ADDENDUM NO. 2 TO PROJECT NO. 47552

ELECTRICAL WORK UPGRADE ELECTRONIC SECURITY SYSTEMS VALLEY RIDGE CIT 274 CHIARINO DRIVE NORWICH NY 13815

November 20, 2024

1 PROGRAM BUILDING SECURITY OFFICE RACK G-J ELEVATION REMOVAL DETAIL
E-731 SCALE: NOT TO SCALE

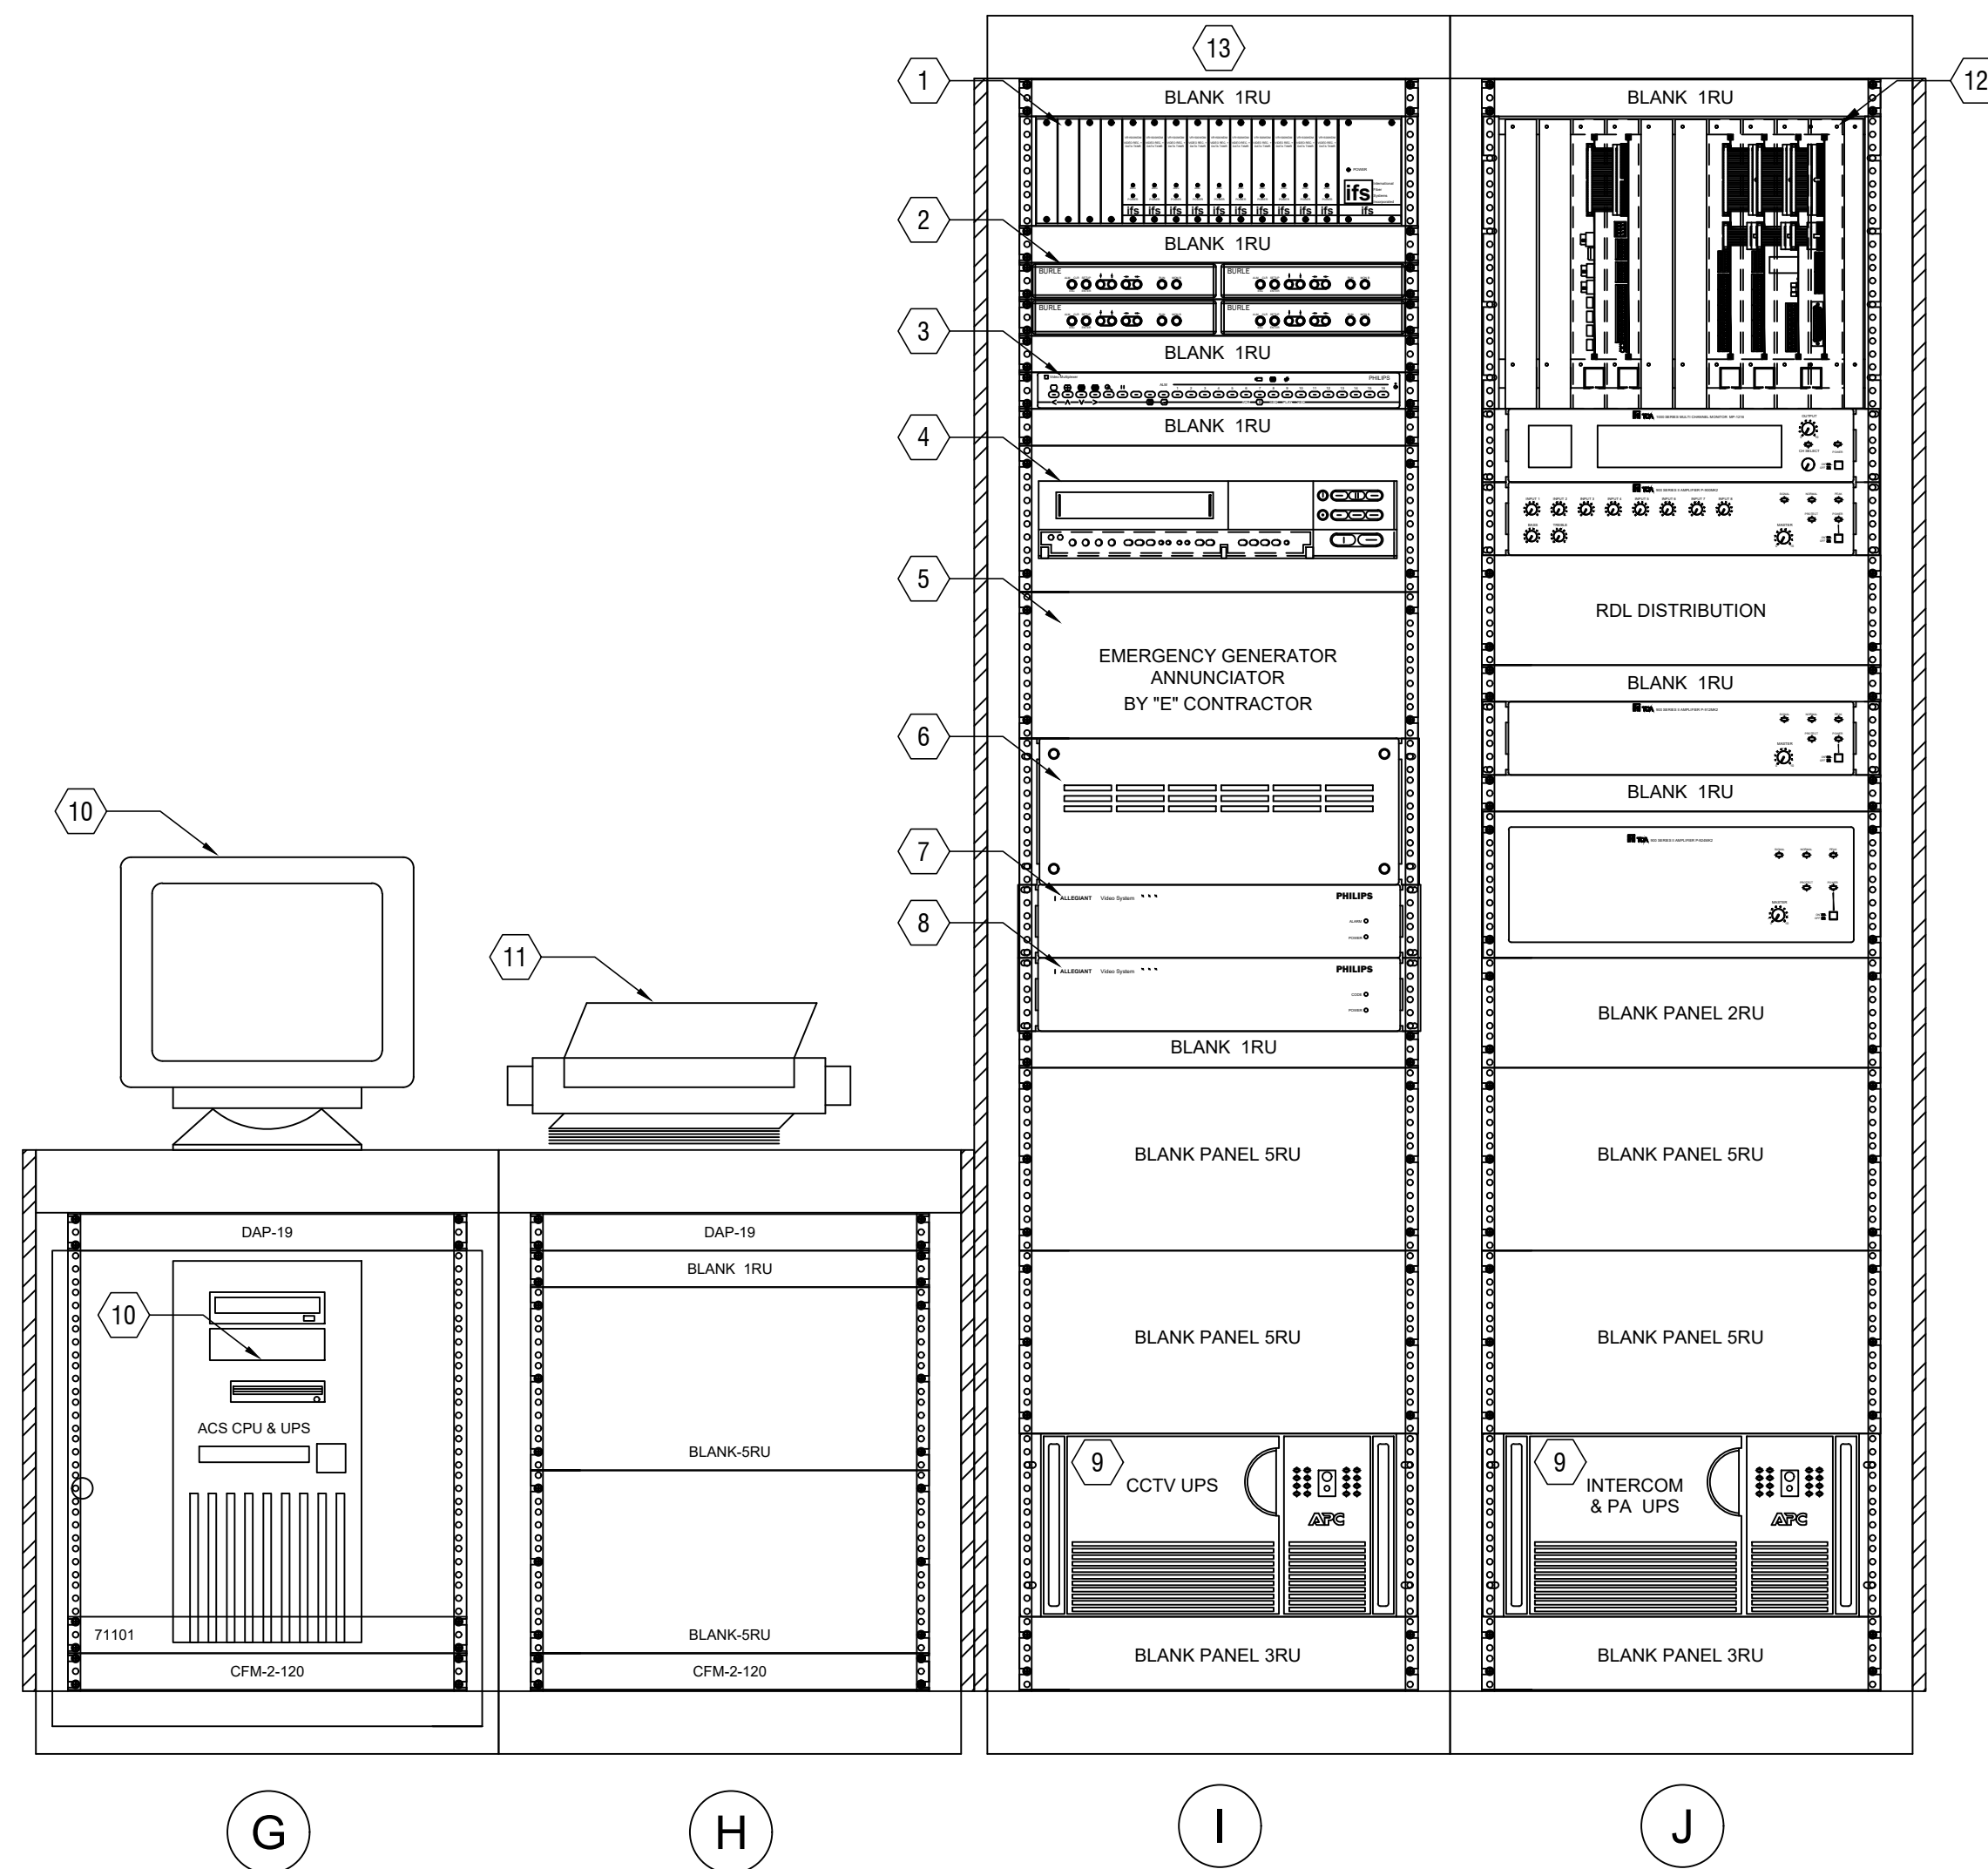
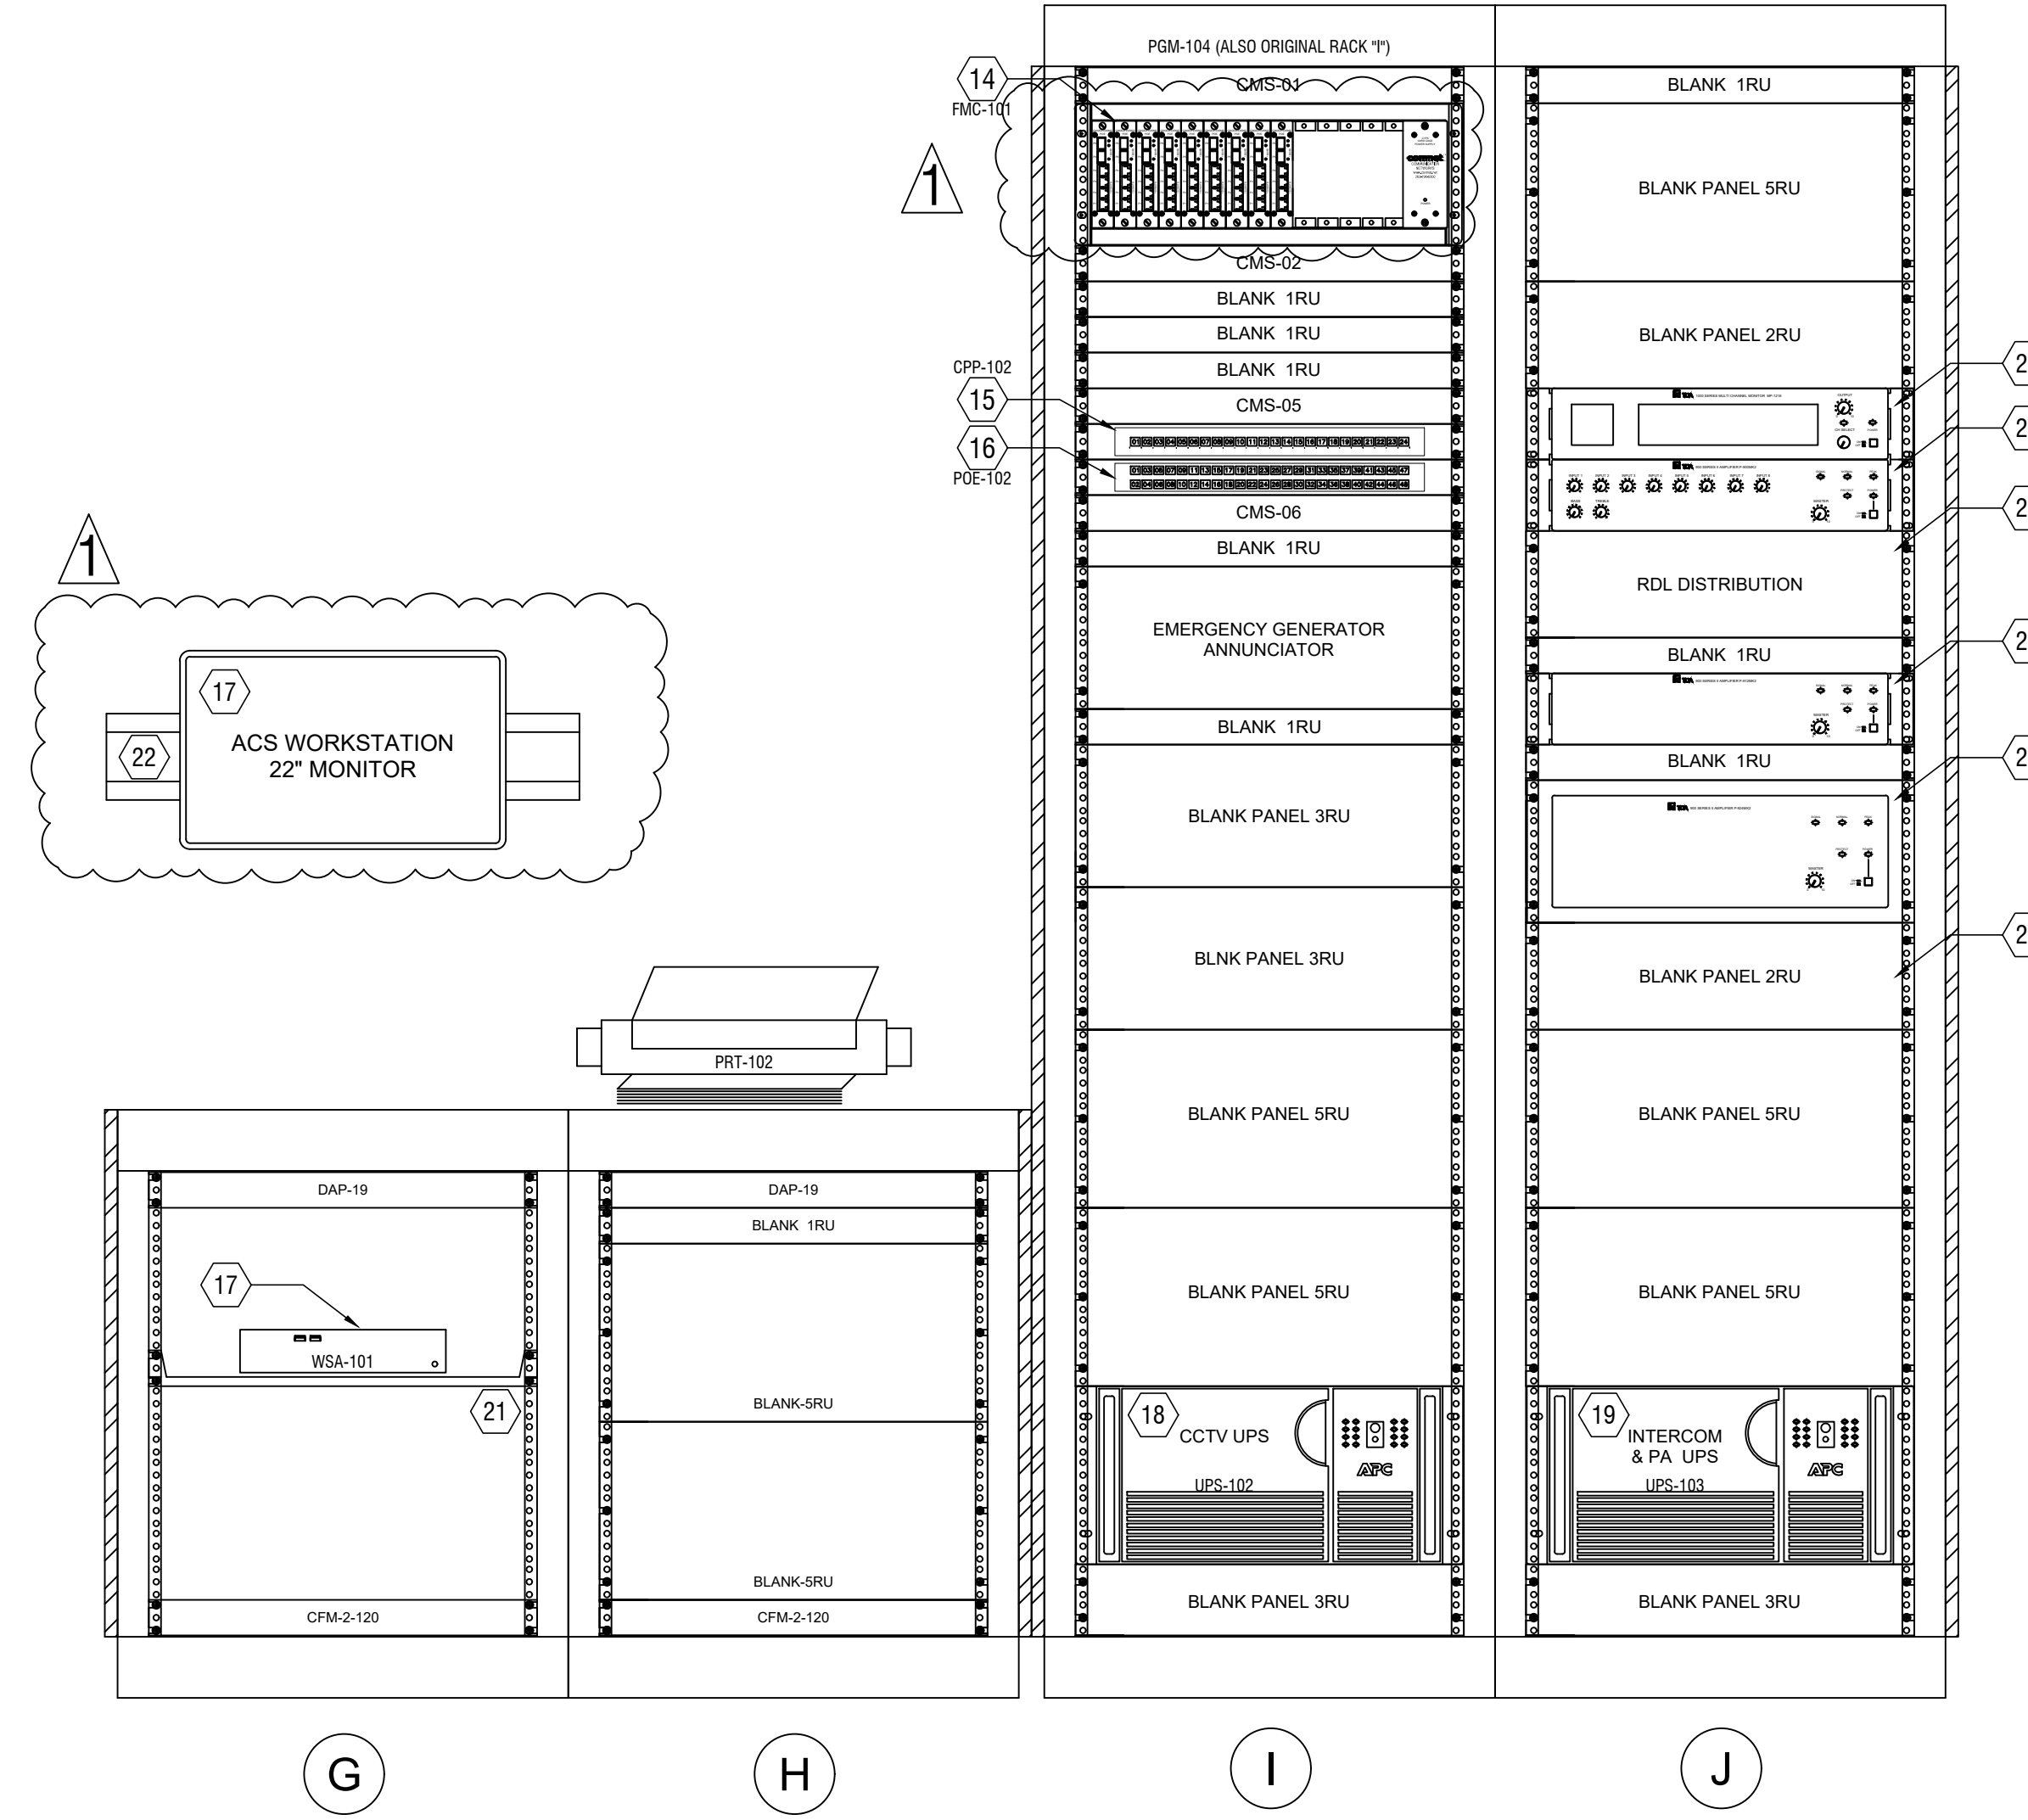
- 1 REMOVE EXISTING FIBER MEDIA CONVERTER.
- 2 REMOVE 4 EXISTING CCTV MOTION DETECTION UNITS.
- 3 REMOVE EXISTING CCTV MULTIPLEXER.
- 4 REMOVE EXISTING CCTV DIGITAL RECORDER.
- 5 EXISTING GENERATOR EQUIPMENT TO REMAIN.
- 6 REMOVE EXISTING CCTV EXCHANGE UNIT.
- 7 REMOVE EXISTING CCTV ALARM MONITOR.
- 8 REMOVE EXISTING CCTV CODE DISTRIBUTION.
- 9 REMOVE EXISTING RACK MOUNT UPS.
- 10 REMOVE EXISTING ACCESS CONTROL WORKSTATION AND MONITOR.
- 11 DOT MATRIX-IMPACT PRINTER TO REMAIN OR UPGRADED.
- 12 REMOVE TOA INTERCOM EXCHANGE AND CABLING, ALL INTERCOMS WILL BE IP ONLY.
- 13 REMOVE ALL EXISTING ACS MONITORING BOARDS FROM REAR OF RACK "I" AFTER SYSTEM CUT-OVER.

- 14 PROVIDE CCTV CAMERA POLE FIBER MEDIA CONVERTER.
- 15 PROVIDE 24 PORT PATCH PANEL.
- 16 PROVIDE 48 PORT POE SWITCH FOR SECURITY DEVICES.
- 17 PROVIDE ACS LOGGING WORKSTATION AND MONITOR.
- 18 PROVIDE UPS FOR NETWORK EQUIPMENT.
- 19 PROVIDE UPS FOR EXISTING PA EQUIPMENT.
- 20 EXISTING PA HEAD END EQUIPMENT TO REMAIN.
- 21 PROVIDE SHELF FOR THIN CLIENT WORKSTATION.
- 22 PROVIDE 39" WALL MOUNTED TRACK FOR MULTIPLE MONITOR CONFIGURATIONS. TRACK WILL ALLOW.
- 23 REPLACE ALL VENTED PANEL WITH SOLID BLANK PANELS.
